PRODUCT BULLETIN #20710Generic Copy

Issue Date: 19-Dec-2014**TITLE:** Change to pocket tray.**PROPOSED FIRST SHIP DATE:** 30-Jan-2015**AFFECTED CHANGE CATEGORY(S):** Packing**FOR ANY QUESTIONS CONCERNING THIS NOTIFICATION:**

New tray:

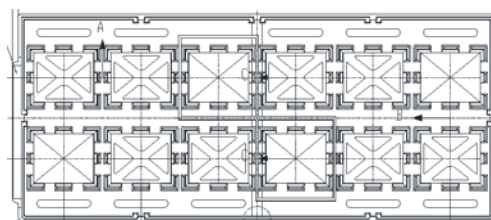
In order to decrease the risk for pin bending on our products we have improved the design of our trays. This is realized by means of individual pockets designed specifically for these devices. Both Minimum Packing Quantity (MPQ) and Minimum Order Quantity (MOQ) are not affected by this change.

The outer dimensions remain identical.
